# PD Modification Application: PRS 25-0570

**Hillsborough  
County Florida**

Request: Minor Modification to PD 19-0284

Proposed PRS 25-0570: The proposed minor modification requests to modify turn lane and sidewalk requirements, the maximum number of units, and layout changes.

### 2.4 Existing Site Plan (Partial)

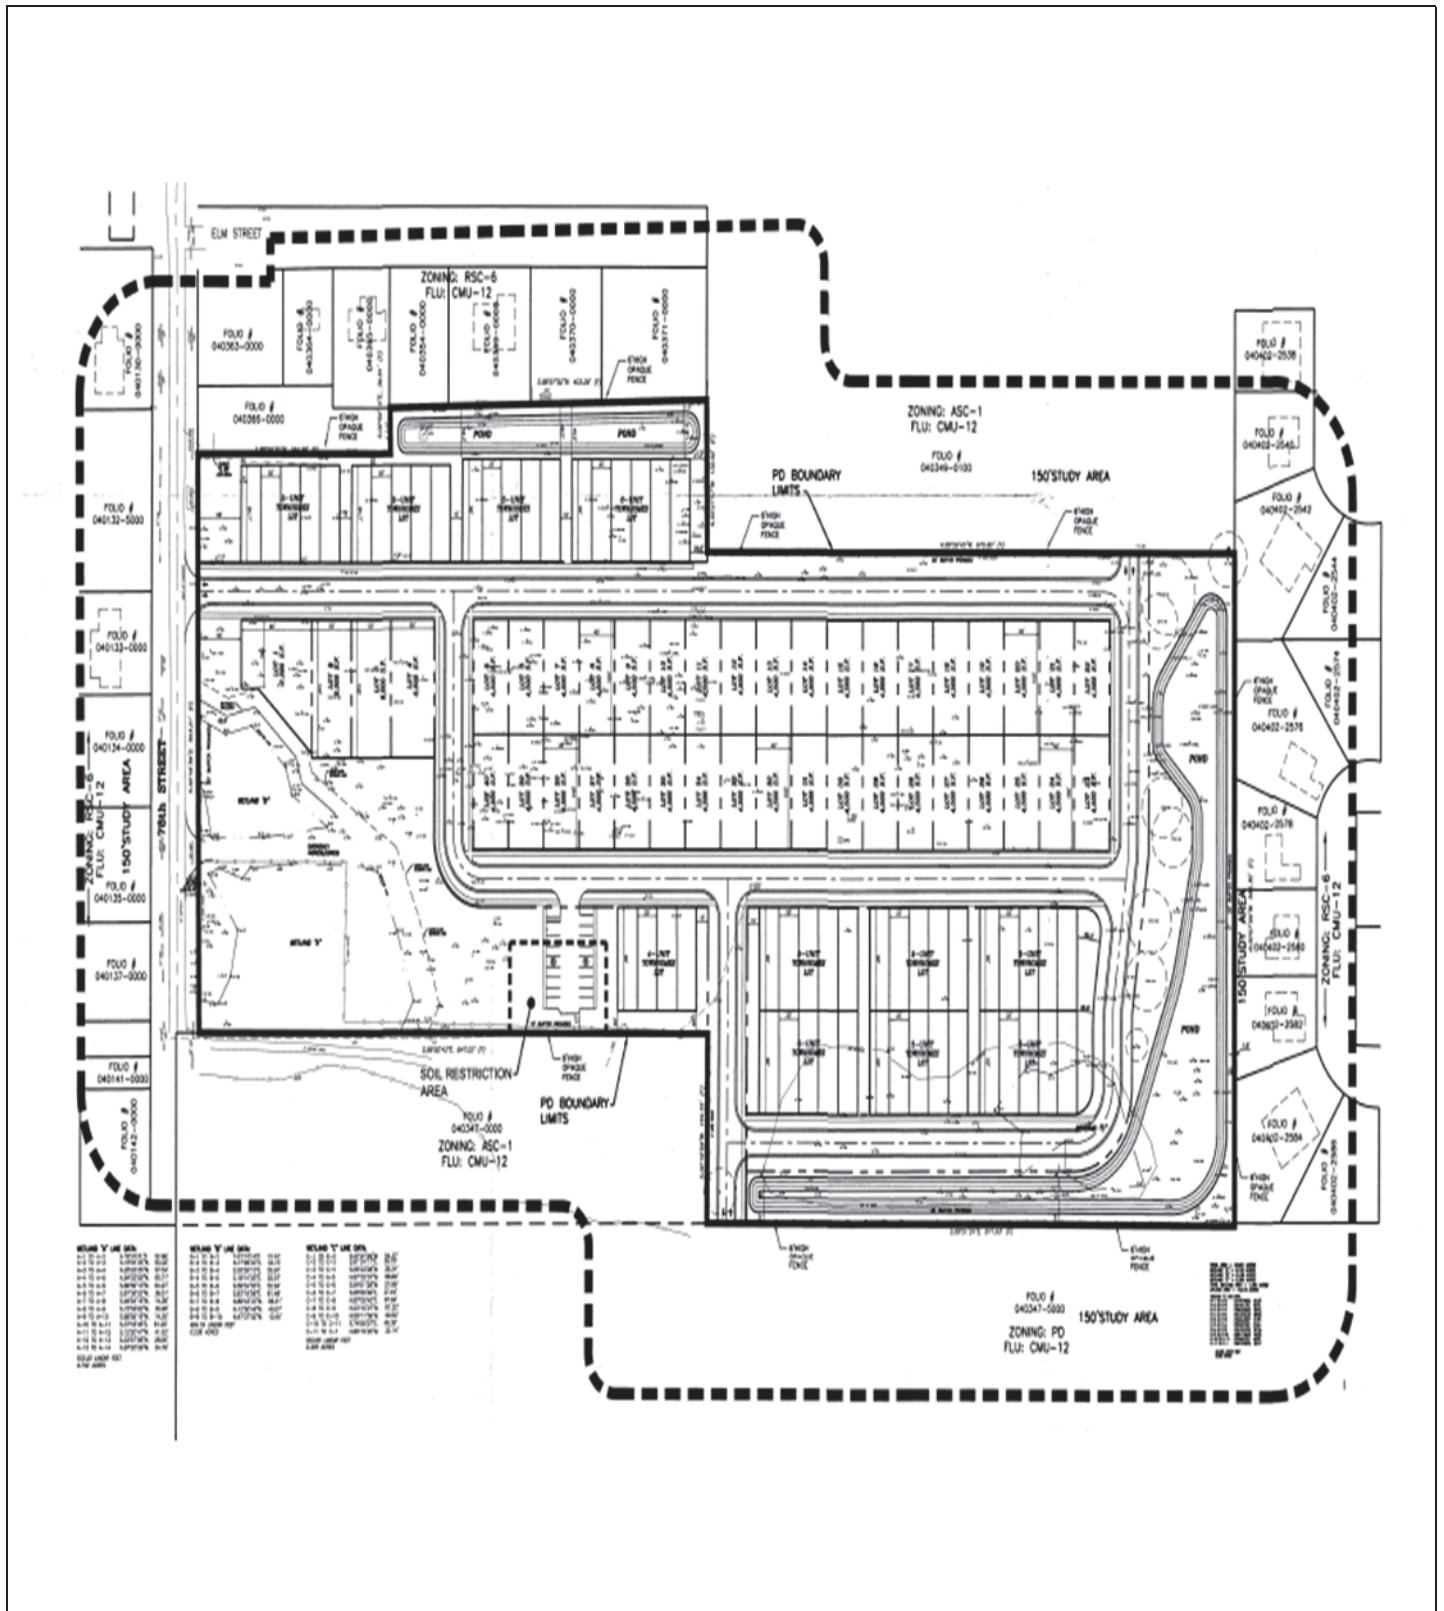
The layout changes due to stormwater modifications will place more separation along the northern boundary and less separation along the southern boundary. Property adjacent to the northern boundary is zoned PD 24-0124 and presently provided with a 20-foot side buffer. PD 24-0124 is currently undeveloped, and the southern boundary is approved for primarily for a stormwater pond, roadway and landscape buffers. Property adjacent to the southern boundary is zoned 80-0090 and undeveloped; and approved for single-family and two family units. All three PDs are proposed to have vehicular connections.

## 2.5 Proposed Site Plan

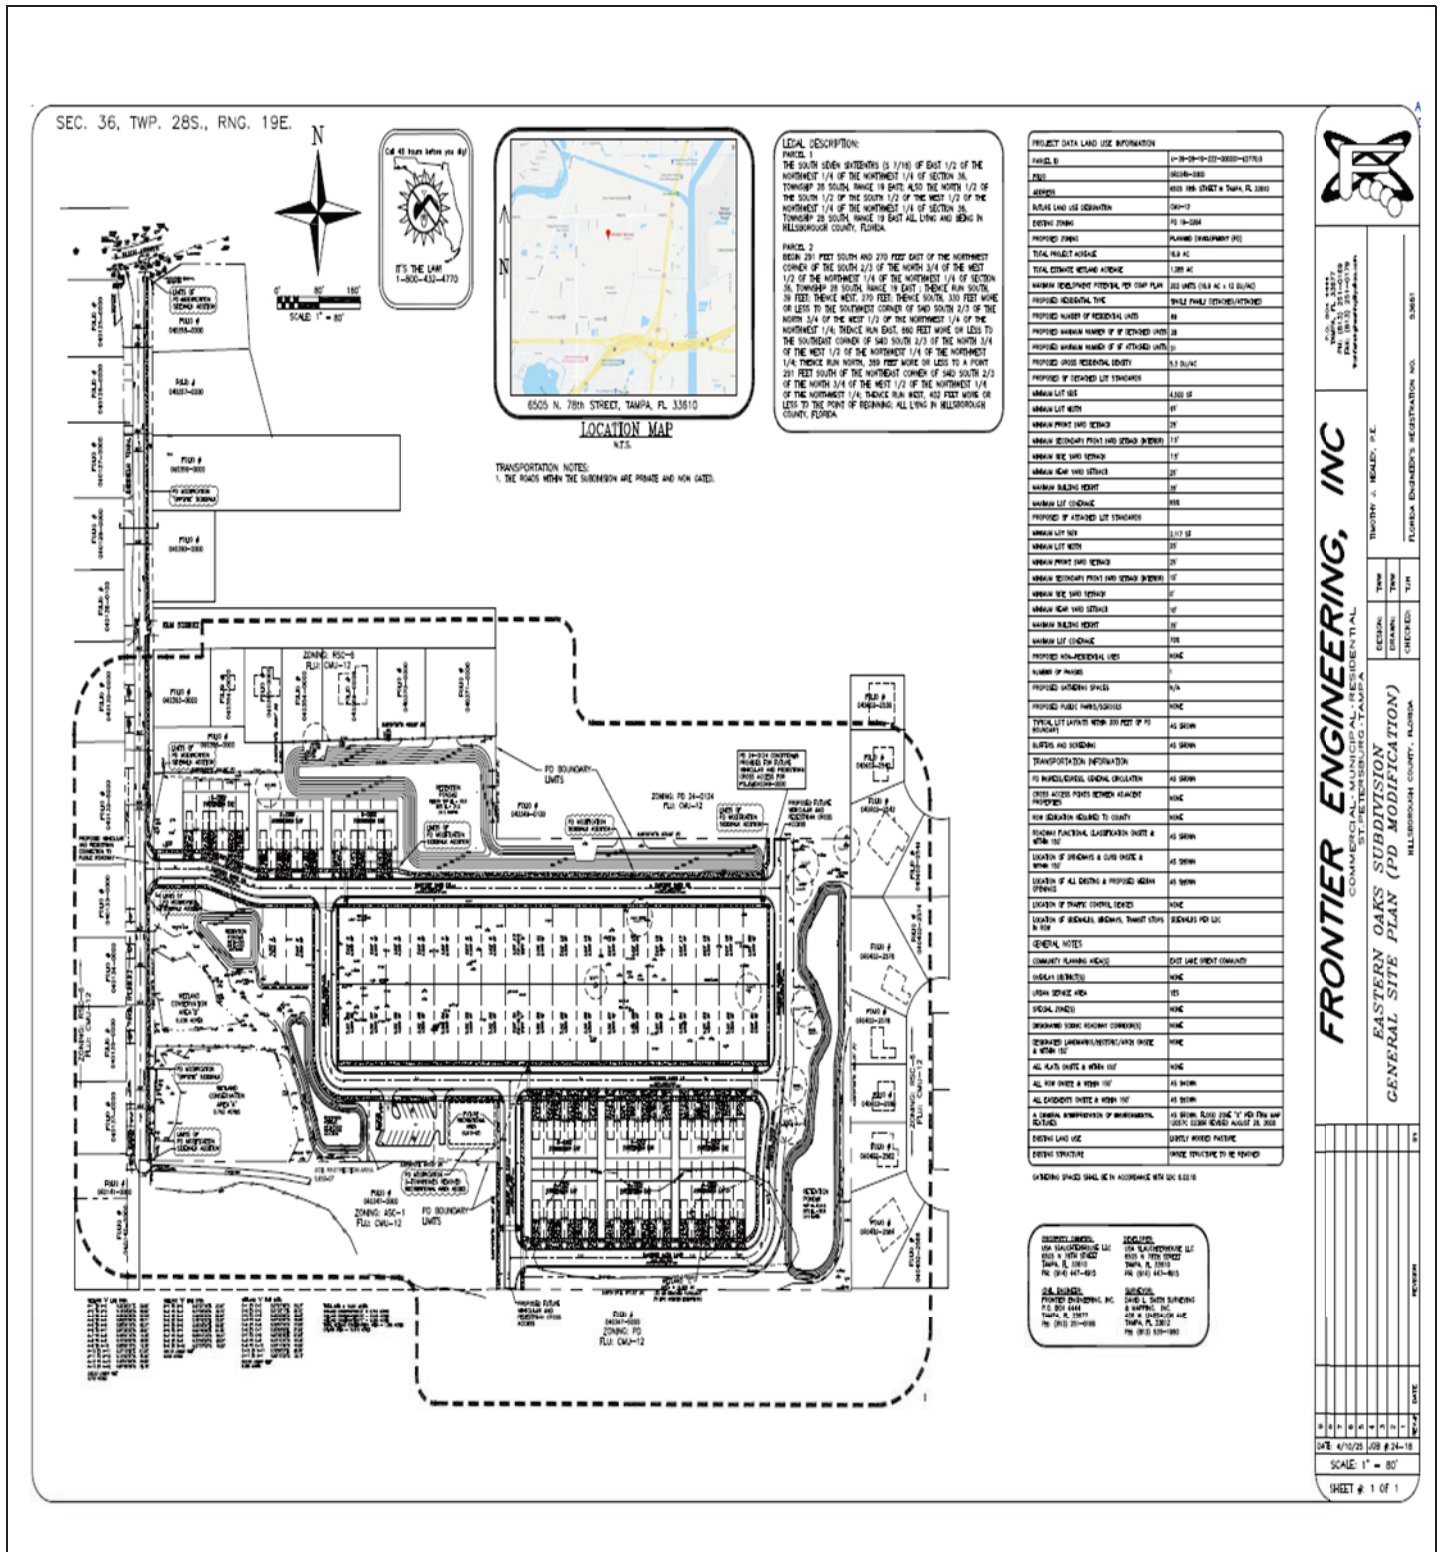
Existing Approval(s):	Proposed Modification(s):
(1) Westbound left turn lane on Sligh Avenue at 78 <sup>th</sup> Street for 95 units.	(1) No westbound left turn lane on Sligh Avenue at 78 <sup>th</sup> Street for 89 units.

(2) Internal sidewalks required.	(2) No sidewalks required along south side of southernmost internal roadway, or along the east side of the easternmost internal roadway (per Design Exception request).

(3) Improve 78 <sup>th</sup> Street to a TS-7 Typical Section roadway.	(3) 10-foot wide travel lanes in lieu of 12-feet; Miami curbing in lieu of roadside ditch; 5-foot wide sidewalk along east side of 78 <sup>th</sup> Street; no sidewalk along the west side of 78 <sup>th</sup> Street; 2-3 foot sidewalk placement from ROW north and south of project access (per Design Exception request).

(4) Maximum of 95 units (40 detached, 55 attached)	(4) Maximum of 89 units (38 detached, 51 attached)

(5) Townhomes limited to 4 attached units in southeast corner of PD.	(5) Townhomes limited to 6 attached units in southeastern corner of PD.
(6) Stormwater located in northwestern, western, eastern, and southern areas of the PD.	(6) Stormwater ponds located in the western, eastern and northern areas of the PD.
(7) Four 5-unit townhome buildings and four single-family detached lots within the northwest area of PD. Additionally, one 4-unit townhome building in the southwestern area of PD.	(7) Three 5-unit townhome buildings and two single-family detached lots within the northwest area of PD. Additionally, recreation area in the southwestern area of PD.

1. The project shall be developed with ~~40~~ 38 single-family conventional detached units and ~~55~~ 51 single-family conventional attached units. The maximum number of residential units shall not exceed ~~95~~ 89. Interim use of passive agriculture shall be permitted.
2. Individual residential lots shall be developed in accordance with the following:

- 3.1 The 3 townhome buildings located at the northwest corner of the PD shall be limited to 5 units. The townhomes located at the ~~southwest~~ southeast corner shall be limited to ~~4~~ 6 units.

18. If RZ 25-0570 is approved, the County Engineer will approve a Design Exception (dated July 2, 2025) which was found approvable by the County Engineer (on July 3, 2025) for a limited number of areas along the eastern boundary of the internal roadway and the southern boundary of the internal roadway (as shown on the PD site plan). Specifically, within this section, the developer shall construct a 5-foot sidewalk on the west side of the easternmost internal roadway and on the north side of the southernmost internal roadway, consistent with the Design Exception.
